ECE/TRANS/WP.29/GRE/2008/39
11 July 2008

REGULATION No. 37
(Filament lamps)

Proposal for Supplement 33 to the 03 series of amendments to Regulation No. 37

Sheet H10W/1

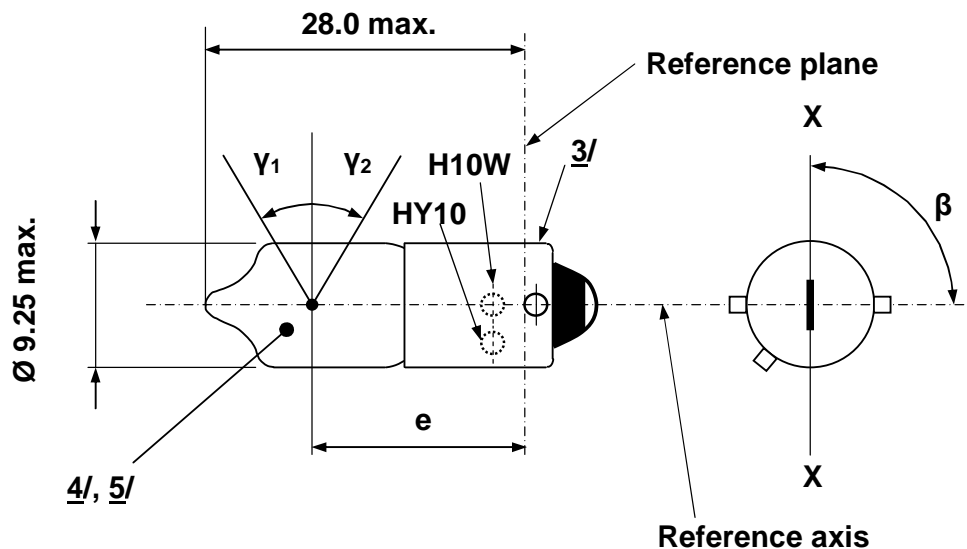
Insert new sheets H10W/1 to 2, between sheet H6W/1 and sheet H21W/1, to read (see next pages):

CATEGORIES H10W AND HY10W

Dimensions in mm		Filament lamps of normal production			Standard filament lamp
		min.	nom.	max.	
e		14.25	15.0	15.75	15.0 ± 0.25
Lateral deviation	<u>1/</u>			0.75	0.4 max
□		82.5°	90°	97.5°	90° ± 5°
γ1, γ2	<u>2/</u>	30°			30° min.
Cap:	H10W: BAU9s HY10W: BAUZ9s	in accordance with IEC Publication 60061 (sheet 7004-...)			
ELECTRICAL AND PHOTOMETRIC CHARACTERISTICS					
Rated values	Volts	12			12
	Watts	10			10
Test voltage	Volts	13.5			13.5
Objective values	Watts	12 max.			12 max.
	Luminous flux	H10W	200 ± 12 %		
		HY10W	120 ± 17 %		
Reference luminous flux at approximately 13.5 V					White: 200 lm Amber: 120 lm

- 1/ Maximum lateral deviation of filament centre from two mutually perpendicular planes both containing the reference axis and one containing axis X-X.
- 2/ In the area between the outer legs of the angles γ_1 and γ_2 , the bulb shall have no optically distorting areas and the curvature of the bulb shall have a radius not less than 50 % of the actual bulb diameter.
- 3/ Over the entire length of the cap there shall be no projections or soldering exceeding the permissible maximum diameter of the cap.
- 4/ The light emitted from filament lamps of normal production shall be white for category H10W and amber for category HY10W.
- 5/ The light emitted from standard filament lamps shall be white for category H10W and amber or white for category HY10W.
